2. AMENDMENT/MODIFICATION NO. 0002	3. EFFECTIVE DATE 9/27/01	4. REQUISITION/PURCHASE REQ. NO.	5. PROJECT NO. <i>(If applicable)</i>
--	-------------------------------------	----------------------------------	---------------------------------------

14. DESCRIPTION OF AMENDMENT/MODIFICATION *(Organized by UCF section headings, including solicitation/contract subject matter where feasible.)*
Sabine-Neches Waterway, Texas, Port Arthur Canal, Junction Area, and Turning Basins in Jefferson County, Texas, Dredging
 (See Attached)

1. The specifications and drawings for Invitation No. DACW64-01-B-0033, Dredging, Port Arthur Canal, Junction Area, and Turning Basins in Jefferson County, Texas, Sabine-Neches Waterway, Texas, advertised 4 September 2001, and for which bids are rescheduled to be opened on 10 October 2001, are hereby modified as follows:

**SABINE-NECHES WATERWAY, TEXAS
PORT ARTHUR CANAL, JUNCTION AREA,
AND TURNING BASINS IN JEFFERSON
COUNTY, TEXAS, DREDGING**

**CROSS SECTIONS
PLACEMENT AREA NO.8
SOUTH TRAINING LEVEE
STA.0+00 TO STA.100+03.05**

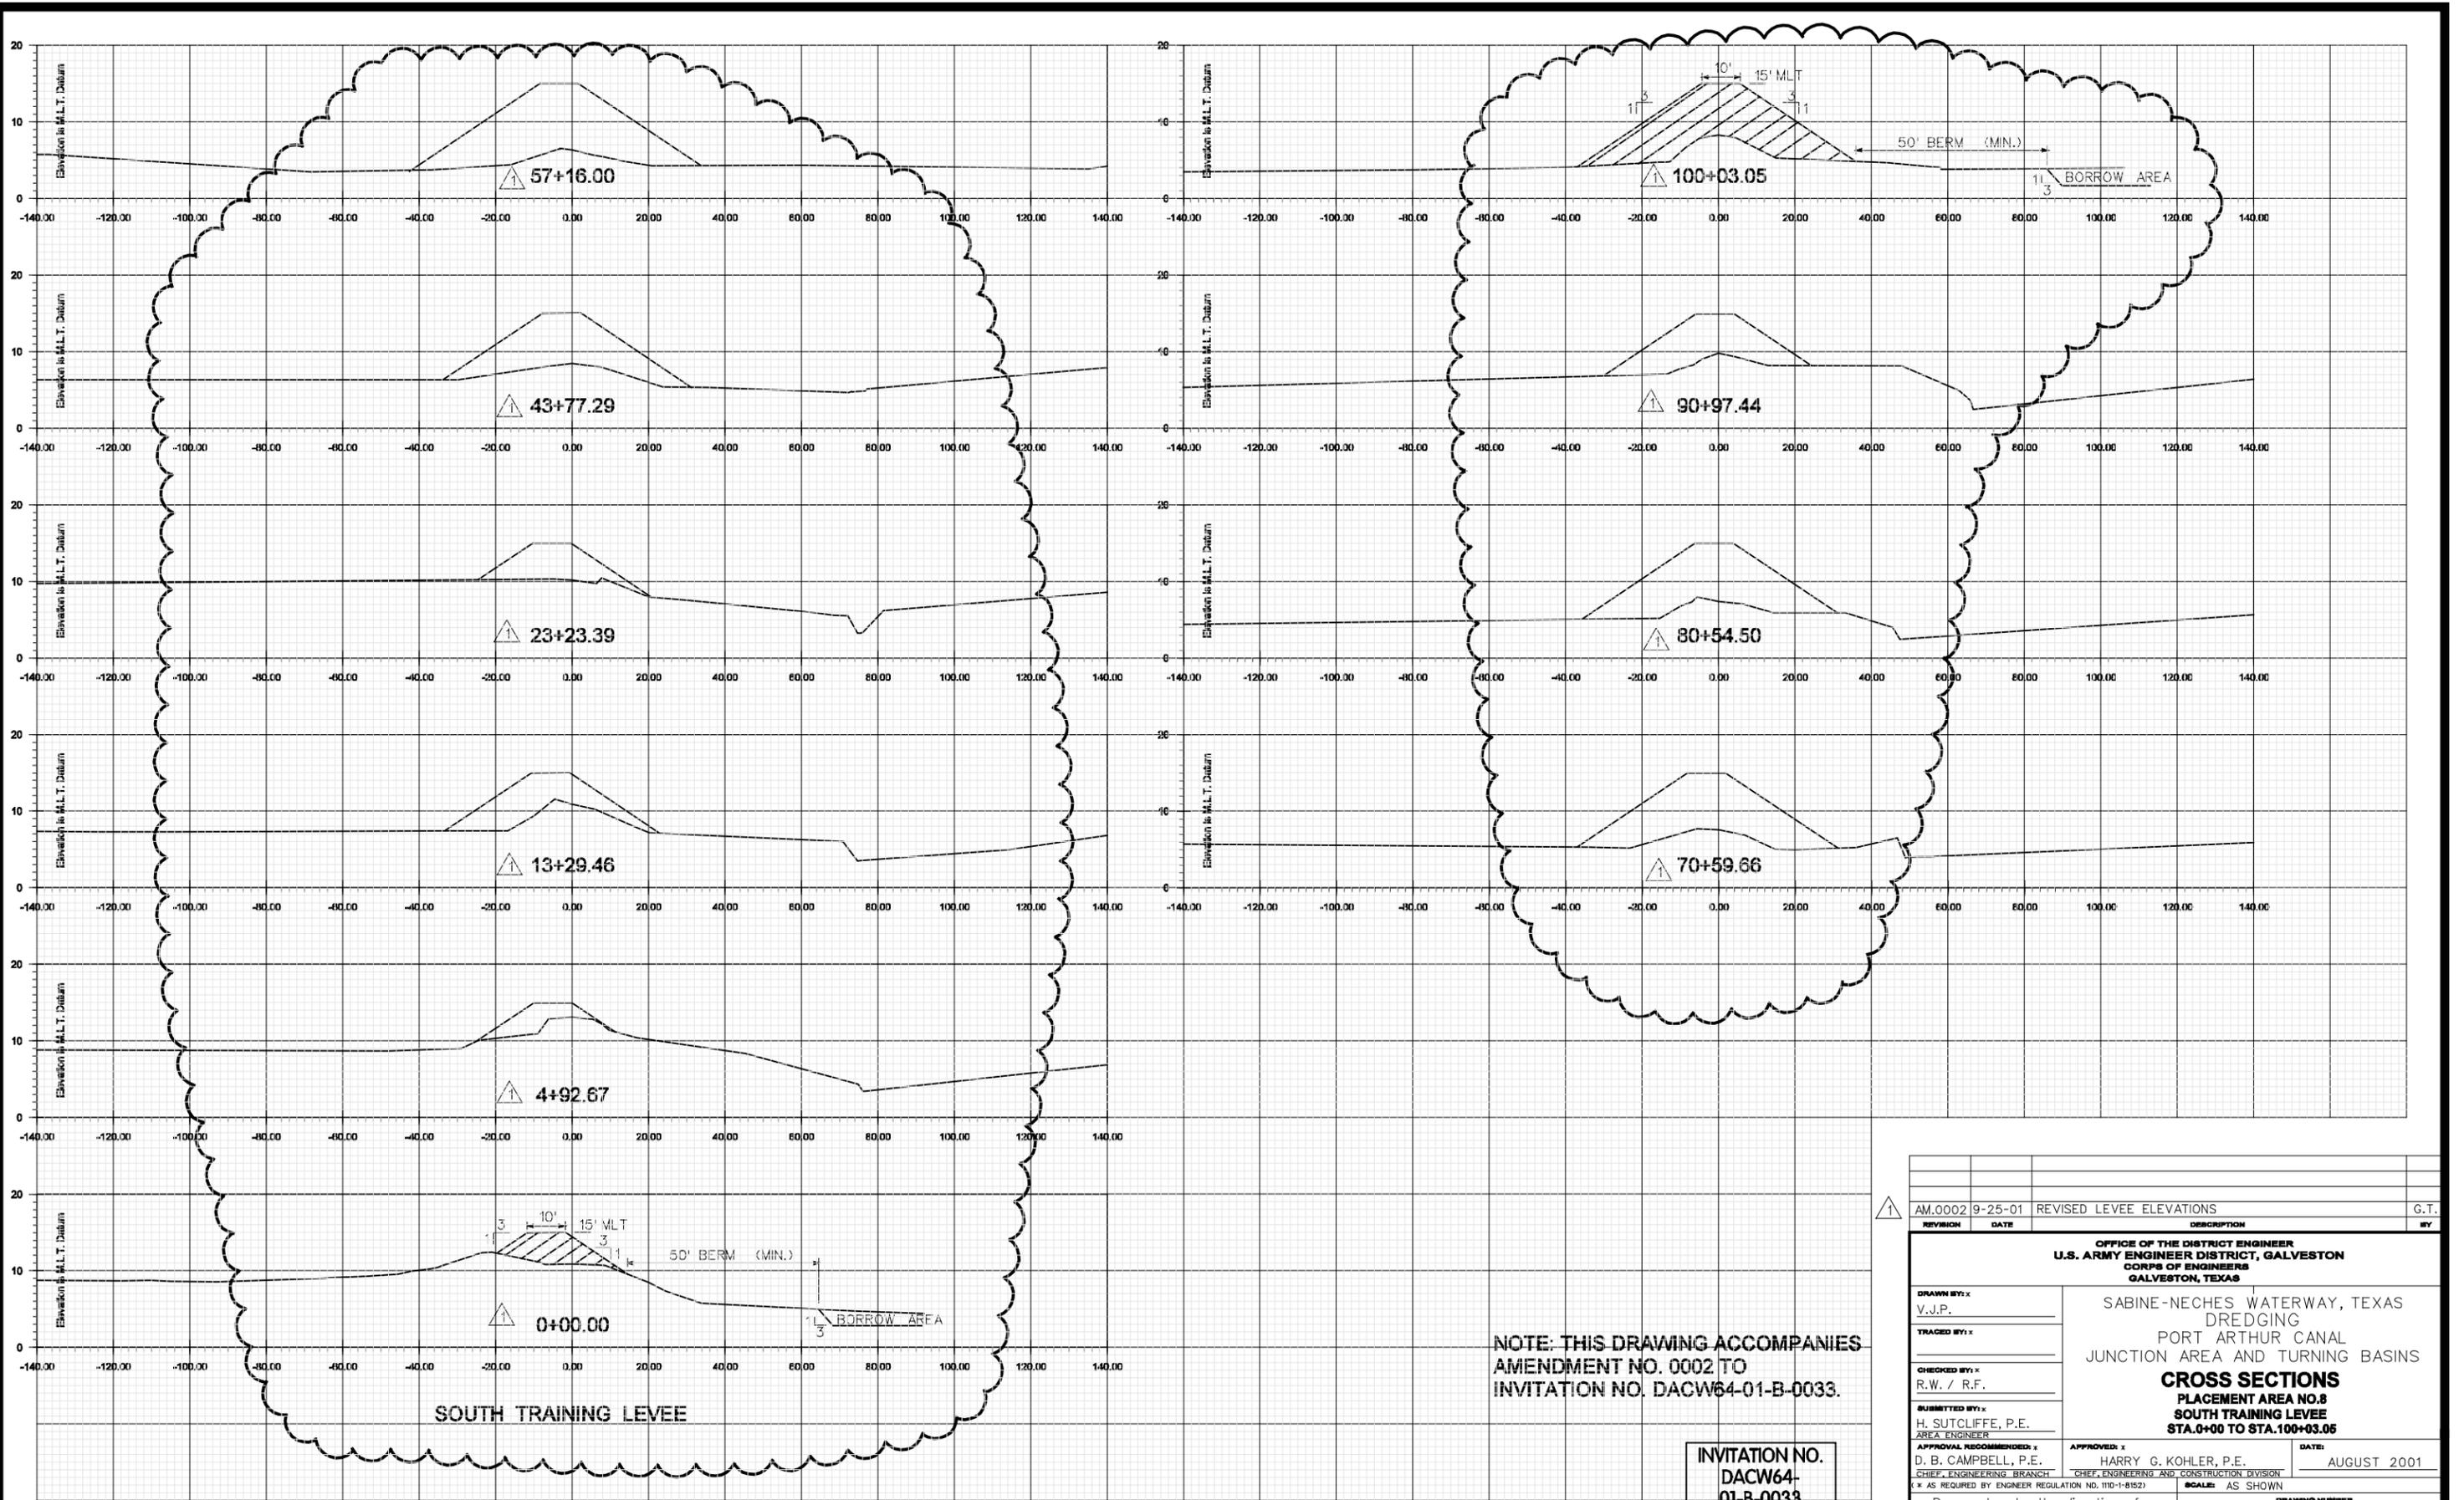
AM.0002	9-25-01	REVISED LEVEL ELEVATIONS	G.T.
REVISION	DATE	DESCRIPTION	BY

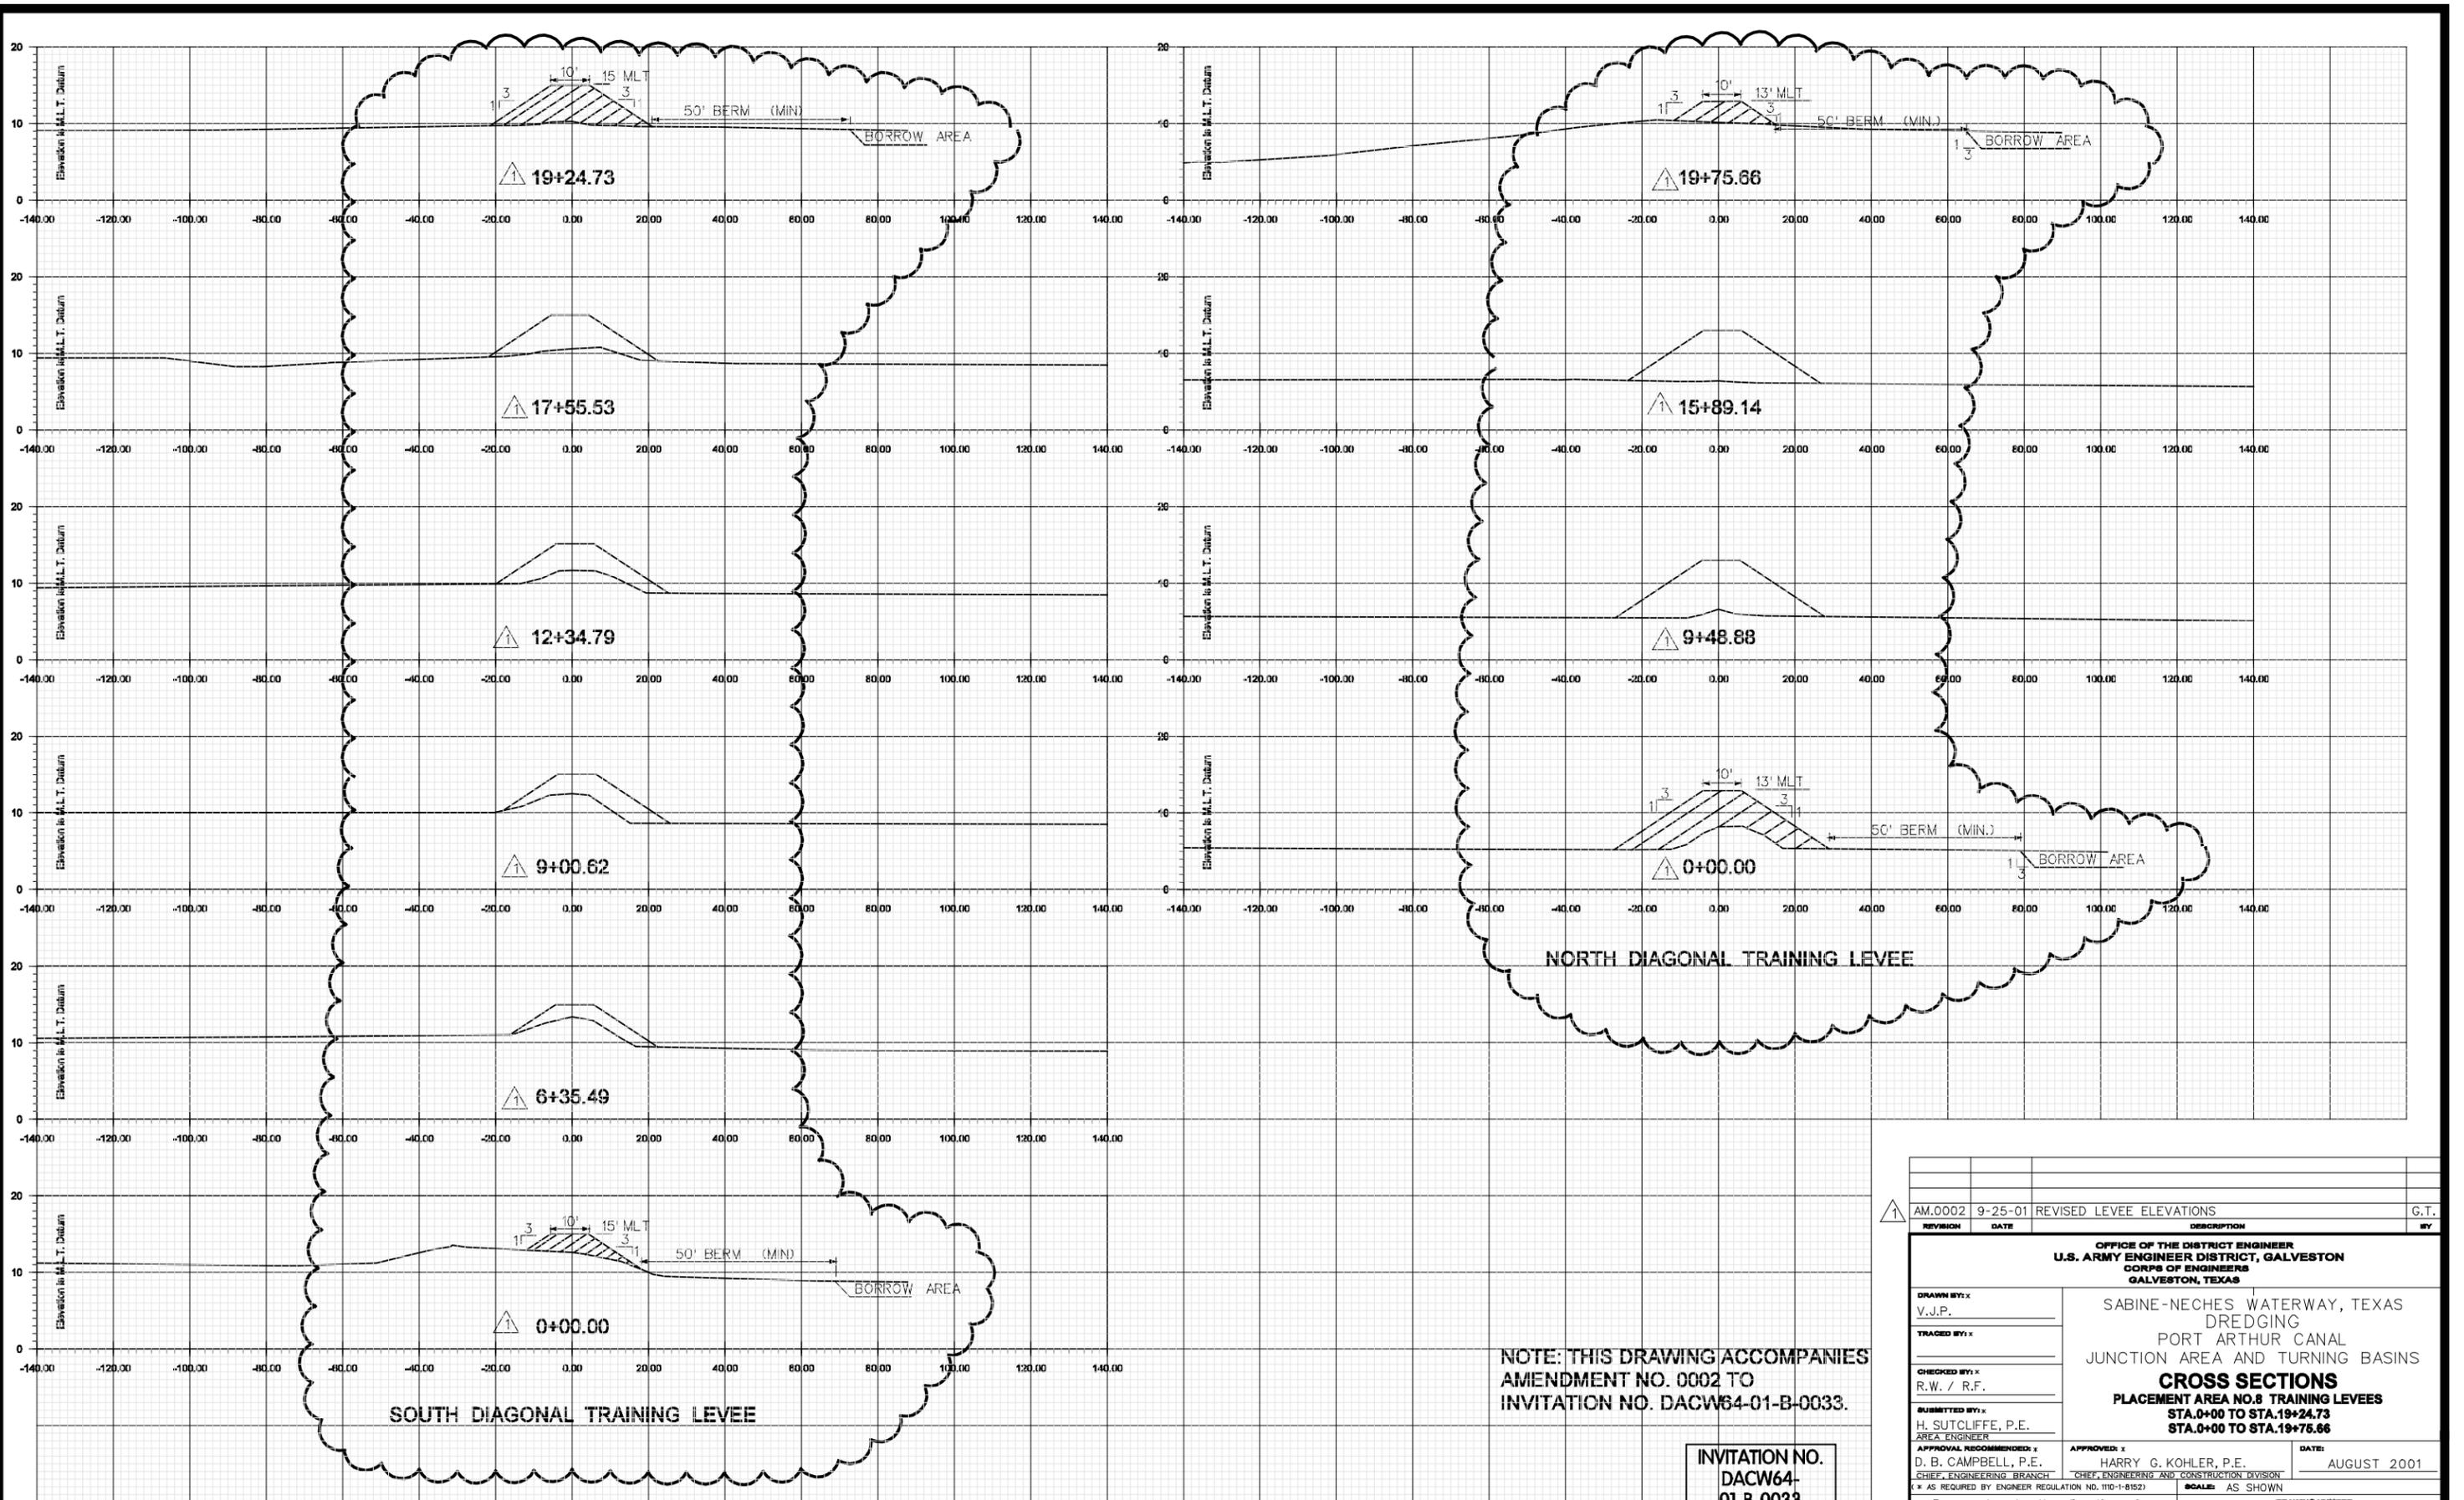
REVISION	DATE	DESCRIPTION	BY
AM.0002	9-25-01	REVISED LEVEE ELEVATIONS	G.T.
